PAVING PLAN

PHASE 1 - KAUMUALII HIGHWAY
LIHUE MILL BRIDGE TO RICE STREET

PHASE 3 - REHABILITATION OF LIHUE MILL
BRIDGE AND MAKAI WIDENING

AS-BUILT

SHEET No. C-41 OF 82      SHEETS

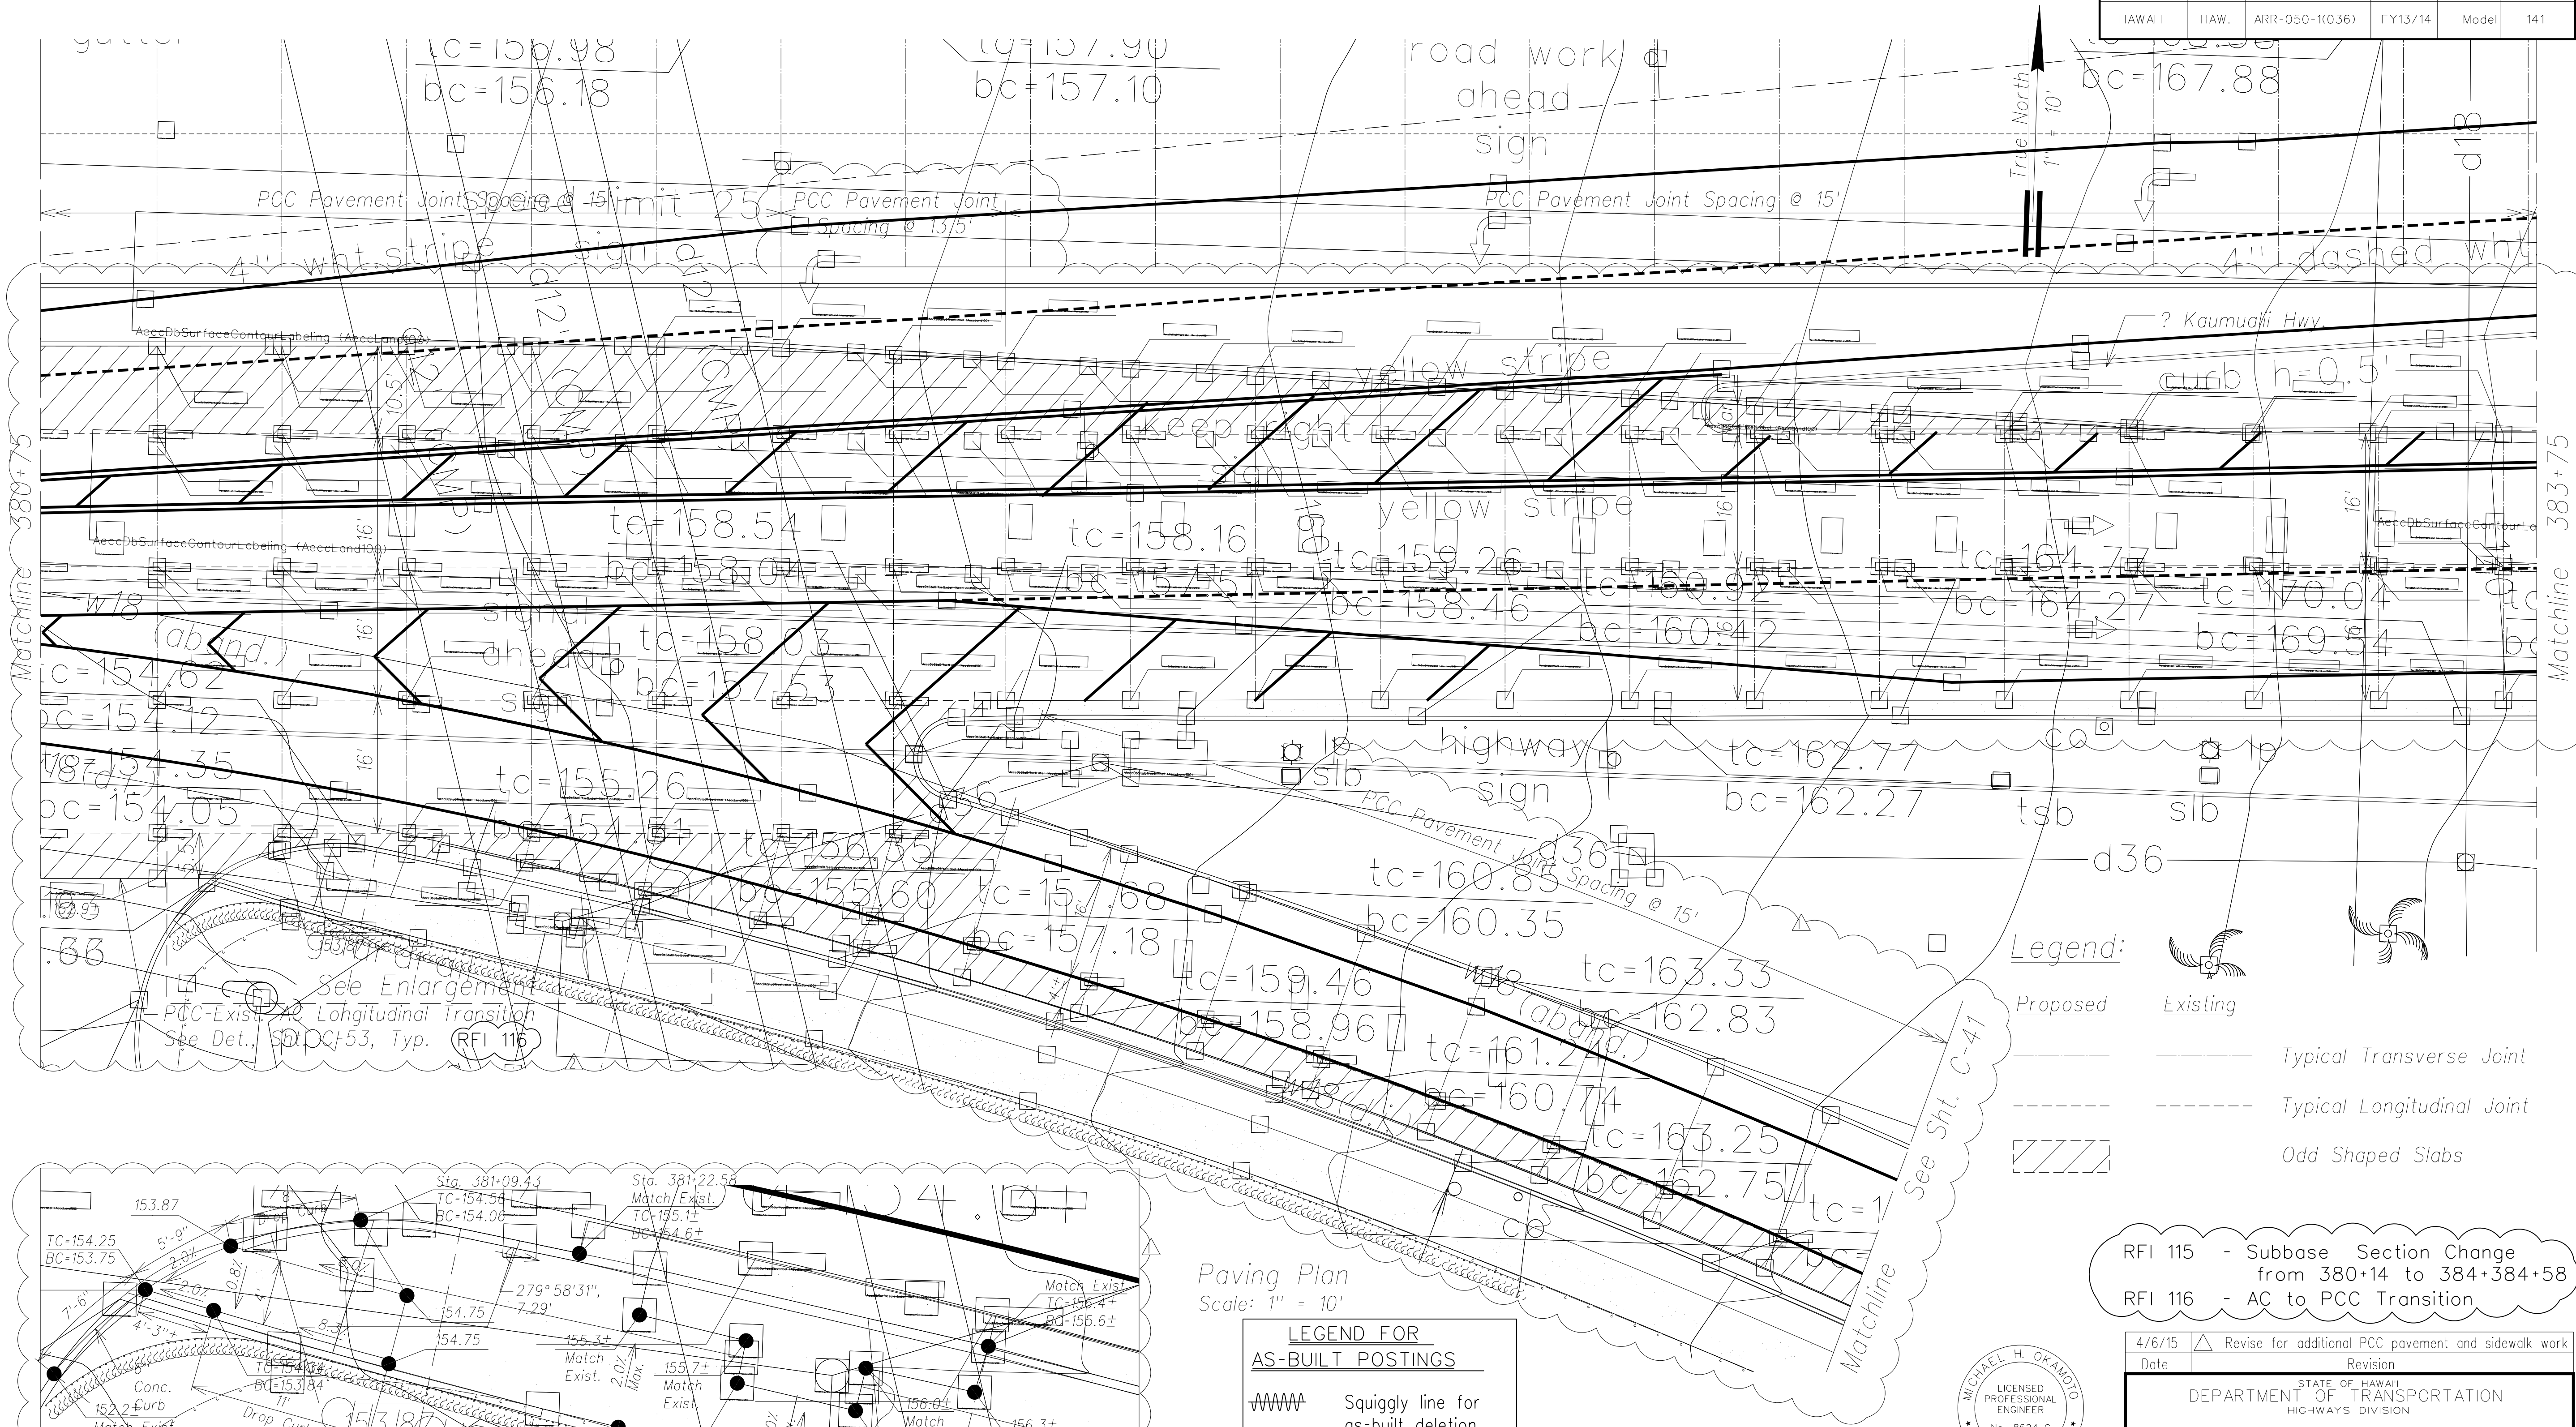
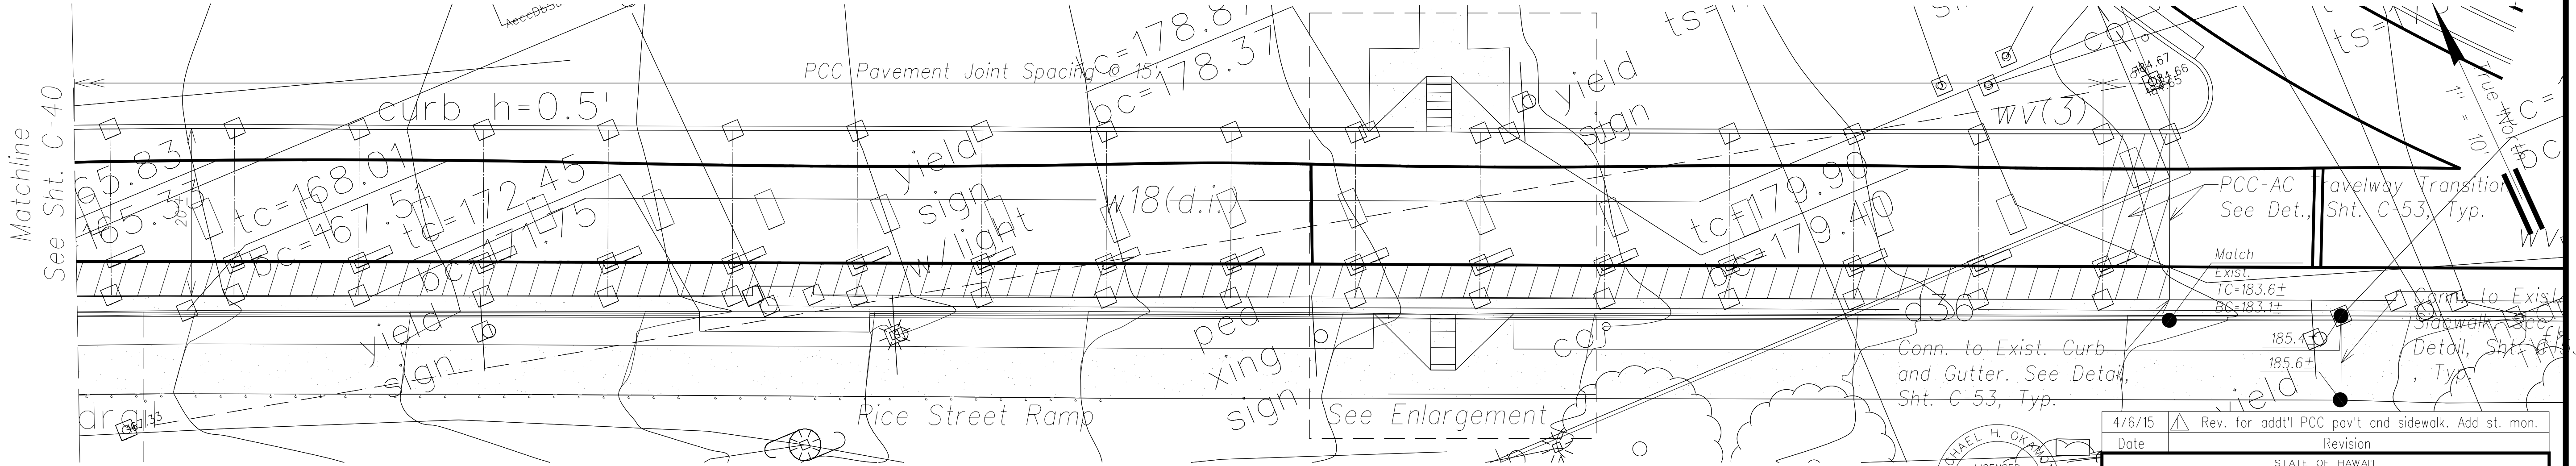
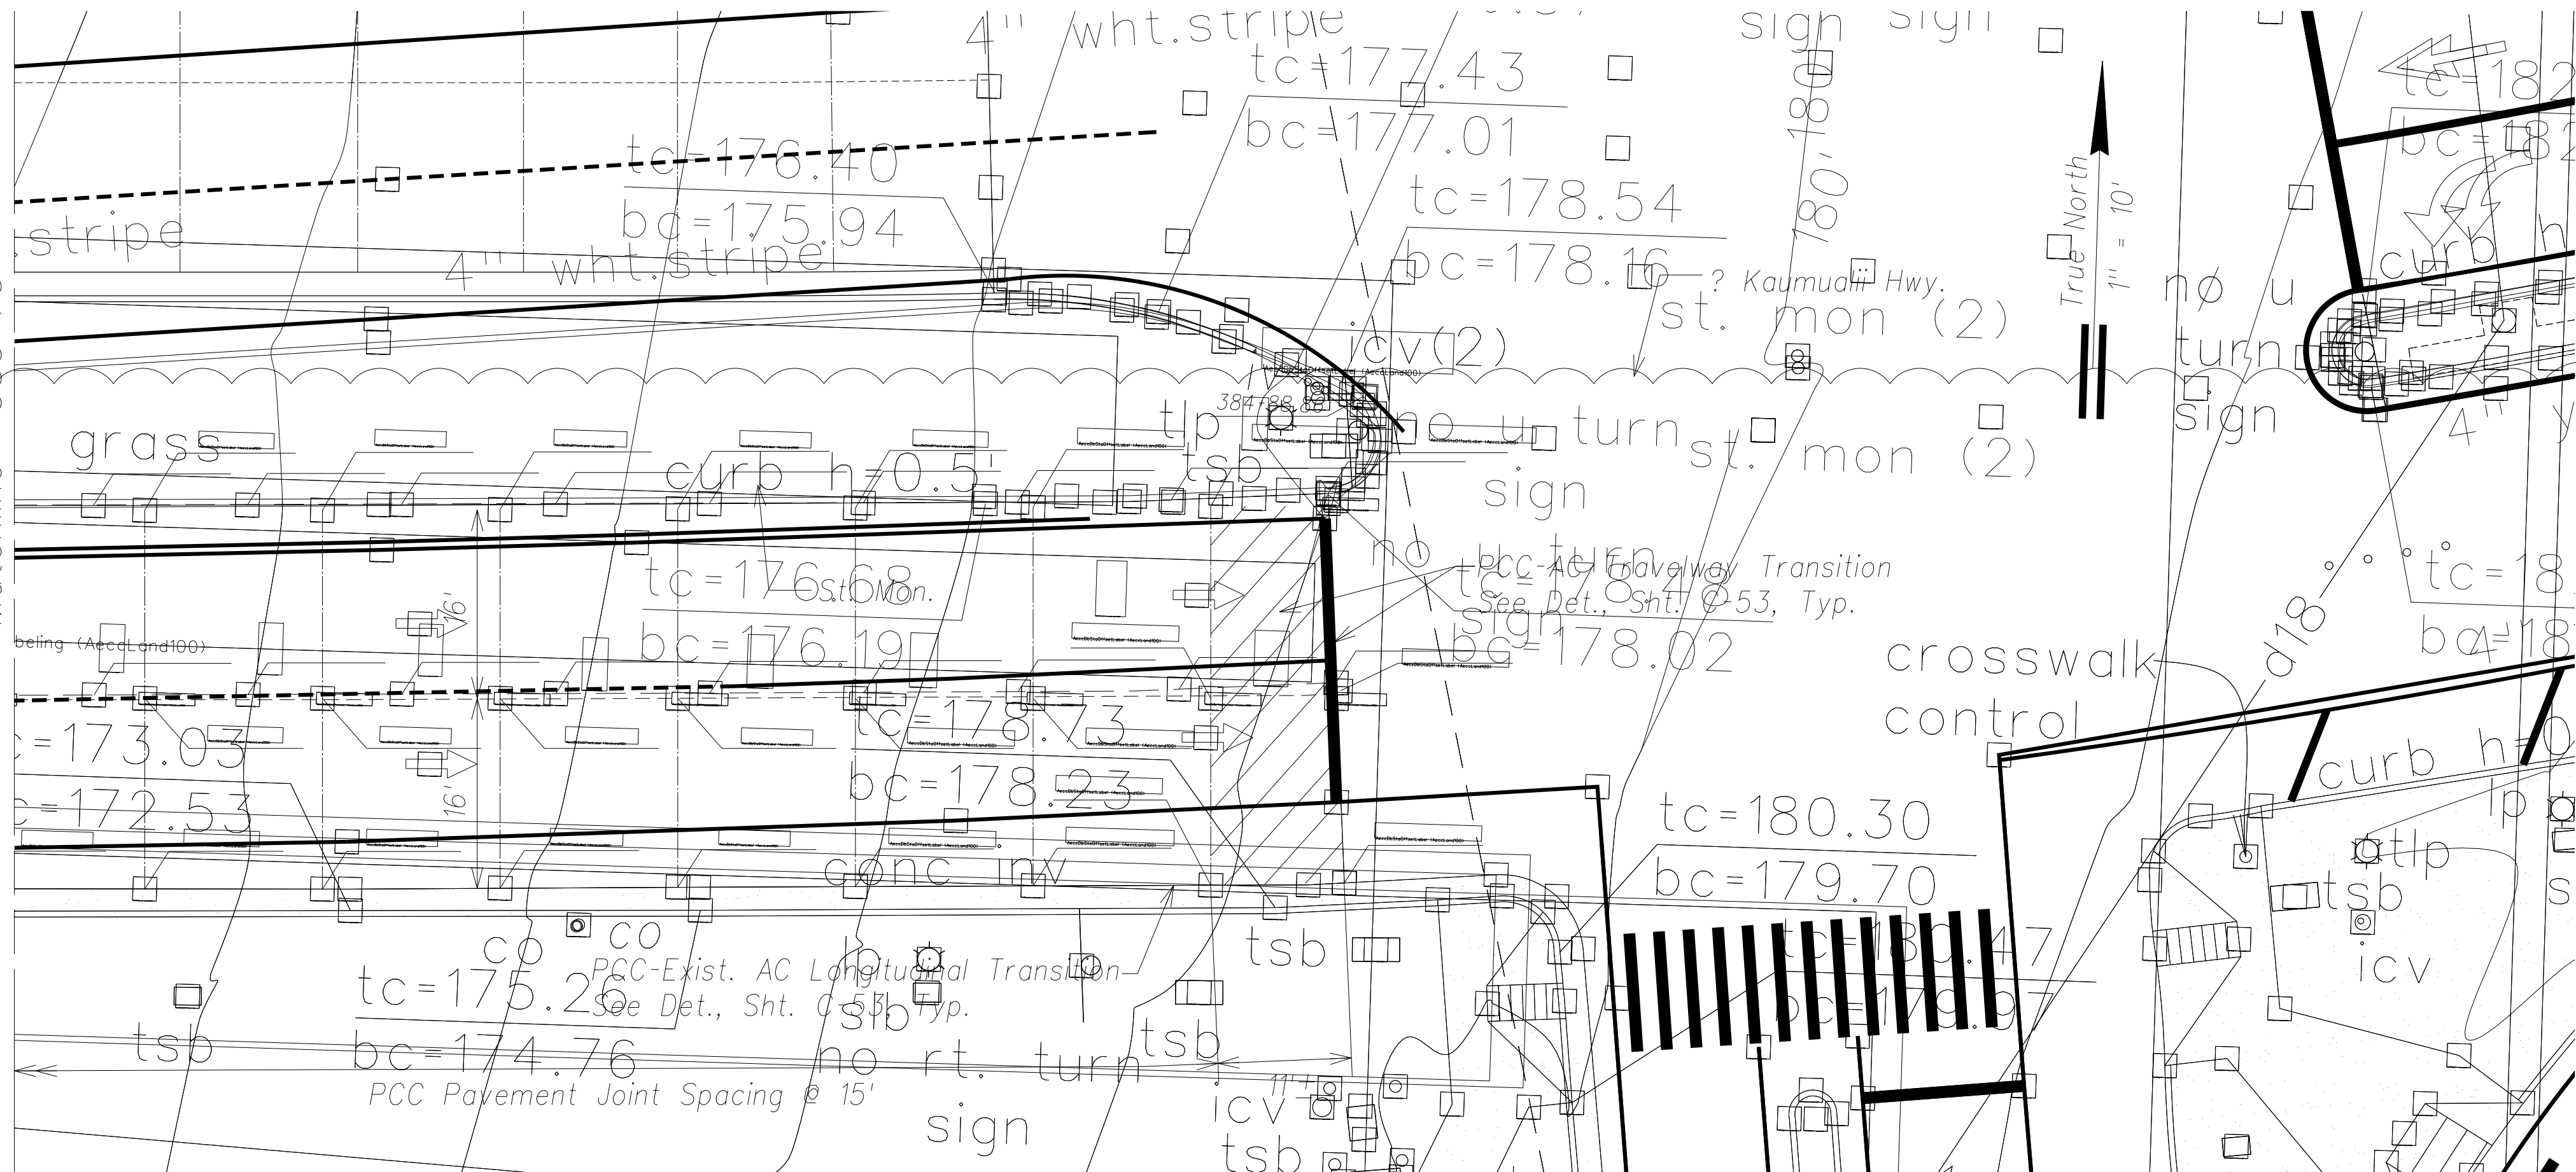
| Date   | Revision                                            |
|--------|-----------------------------------------------------|
| 4/6/15 | Rev. for add'l PCC pav't and sidewalk. Add st. mon. |
